Comments against D2.0 for  
discussion on  
MMF ad hoc 16<sup>th</sup> Jan 2014

Working document maintained by  
jonathan king

# Comments/responses for discussion

# Comment 173 – slide 2

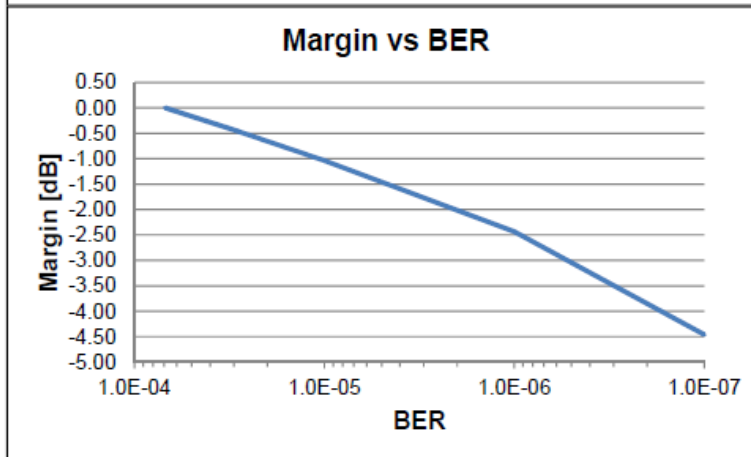
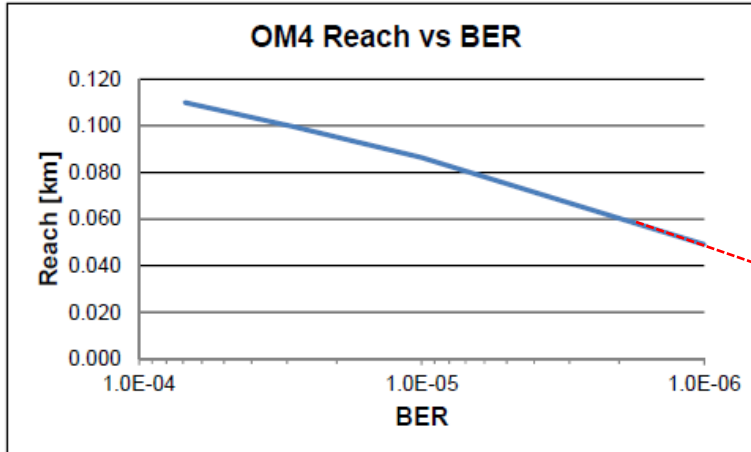
There are low latency applications that will seek to operate a 100GBASE-SR4 link with FEC disabled. There is no stated operating range in Table 95-5 that can be achieved with FEC disabled.

Add footnote to Table 95-5 stating either "There is no required operating range with FEC disabled" or "With FEC disabled, the required operating range is <0.5 m to <TBD value> m for OM3 and <0.5 m to <TBD value> m for OM4."

The agreed link model showed no link distance could be guaranteed without the RS-FEC (see petrilla\_03\_1112\_mmf) and additional optical specs on the transmitter (e.g. RIN).

‘Proposed accept in principle’

- The agreed link model showed no link distance could be guaranteed without the RS-FEC, (see petrilla\_03\_1112\_mmf).
- Add footnote to Table 95-5 stating “FEC may not be disabled for any reach”
- Add footnote to Table 95.1, RS-FEC row: “The option of disabling the Clause 91 FEC may not be used” *final wording to be agreed in comment resolution*
